## **REMARKS/ARGUMENTS**

Serial No. 09/886,346 Amdt. dated August 19, 2004 Reply to Office Action of May 19, 2004

FIG. 3

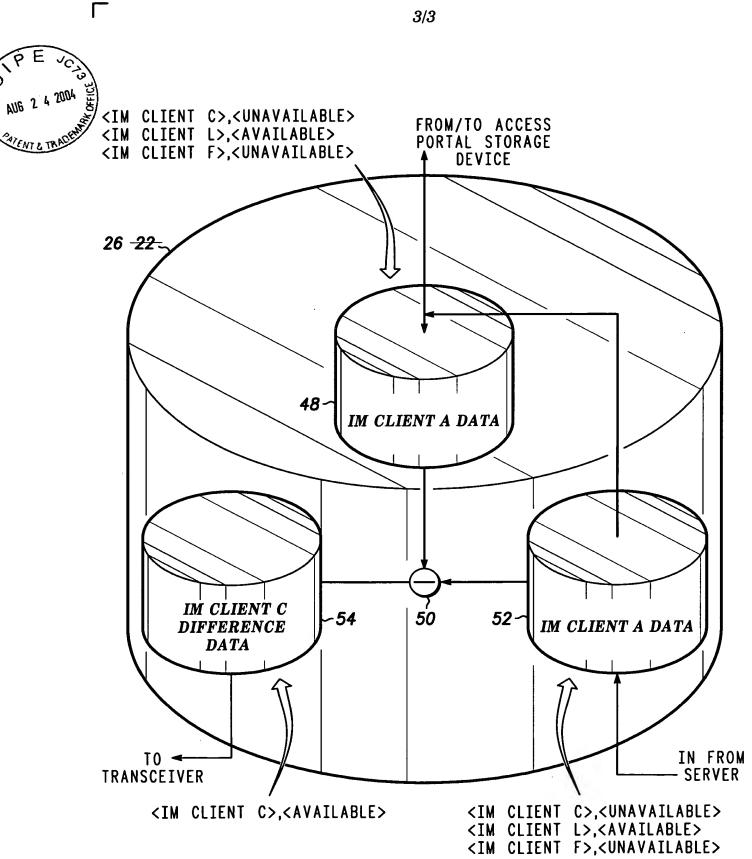
The drawings are objected to as failing to comply with 37 C.F.R. §1.84(p)(5) because they do not include reference numeral "26" mentioned in the specification. In amended FIG. 3, reference numeral "22" has been changed to reference numeral "26" to be consistent with page 6, lines 9 and 10, of the specification. Reconsideration and withdrawal of the 37 C.F.R. §1.84(p)(5) objection to the drawings are respectfully requested.
